Public Hearing on Amendment to: *The Bordeaux – Whites Creek Community Plan – 2003 Update*

Metro Planning Commission Meeting of 1/22/04

Attachment A to Resolution _____ Amendment #1 to the Bordeaux/Whites Creek Community Plan - 2003 Update

FIGURE 1-A

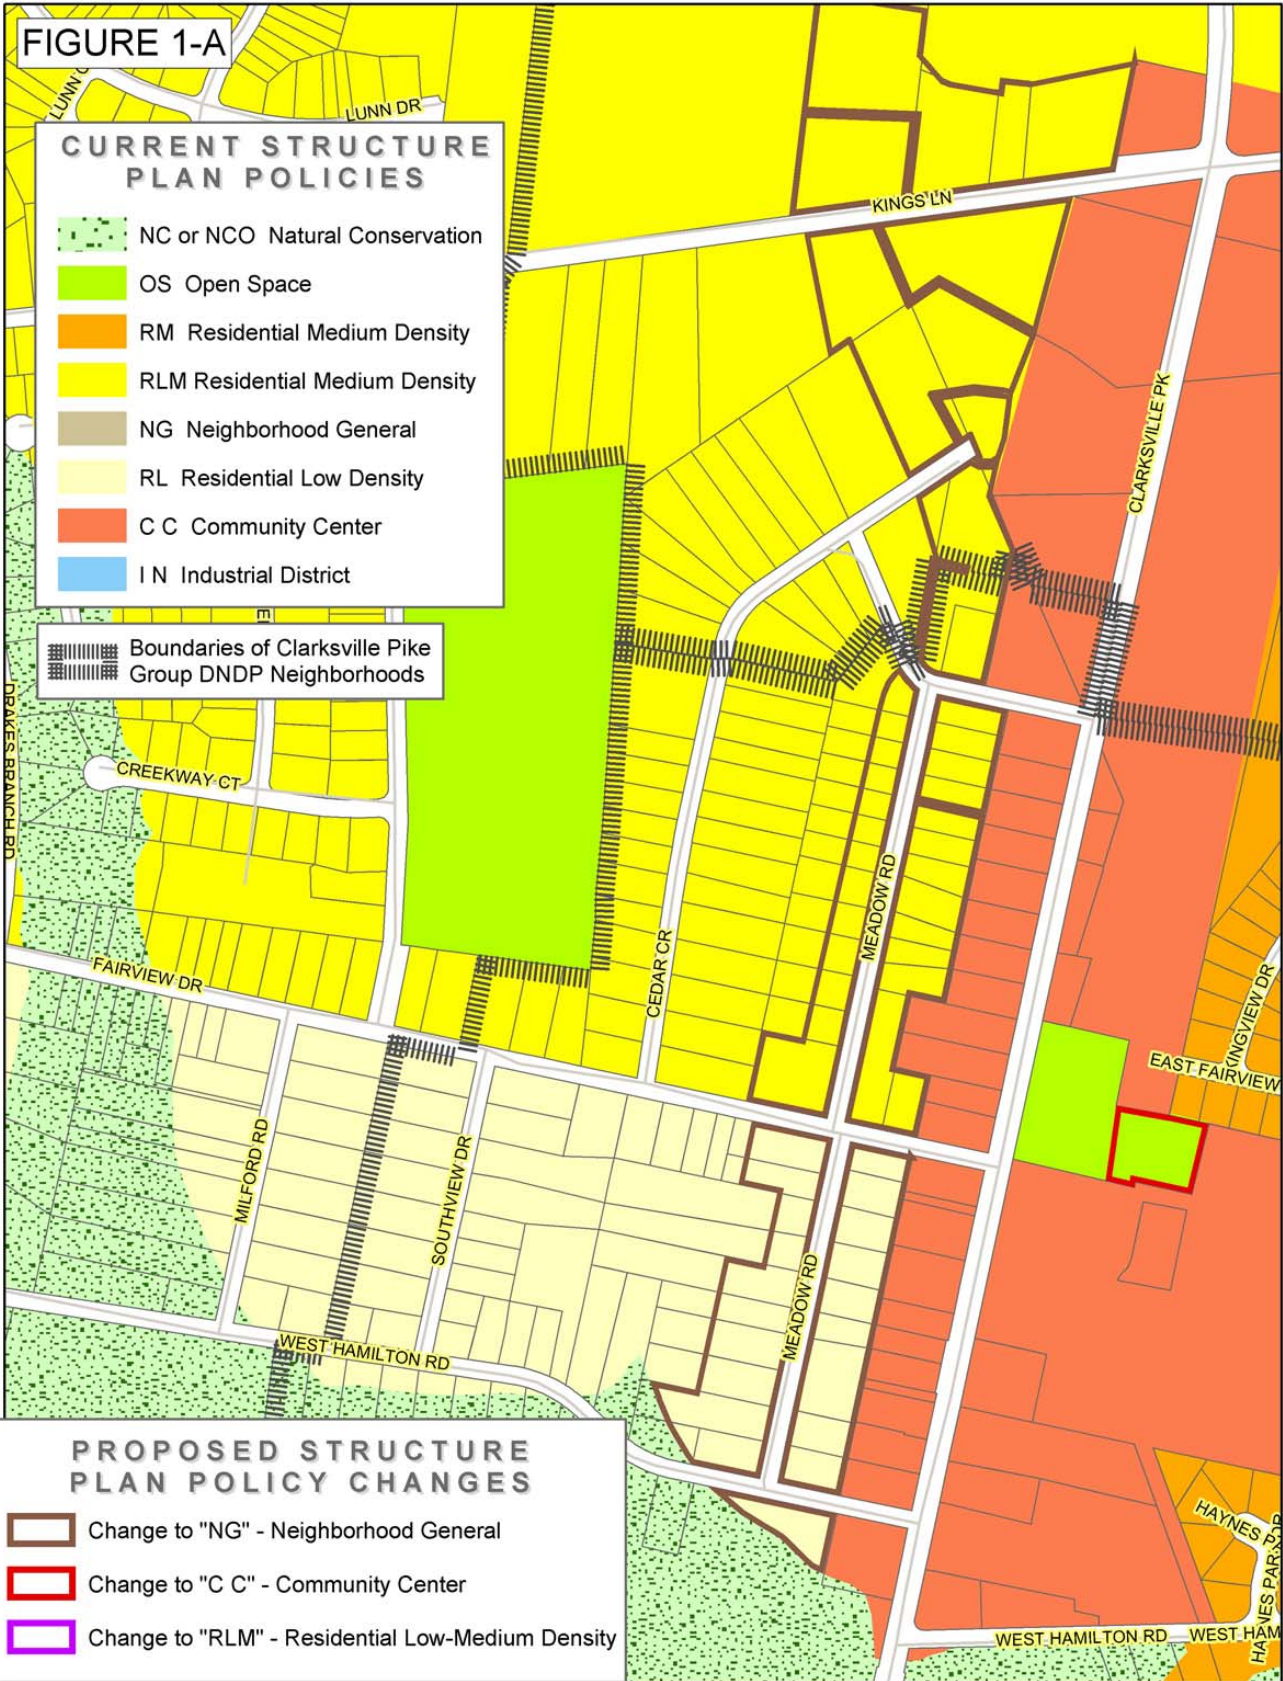
PROPOSED STRUCTURE PLAN POLICY CHANGES

-  Change to "NG" - Neighborhood General
-  Change to "C C" - Community Center
-  Change to "RLM" - Residential Low-Medium Density
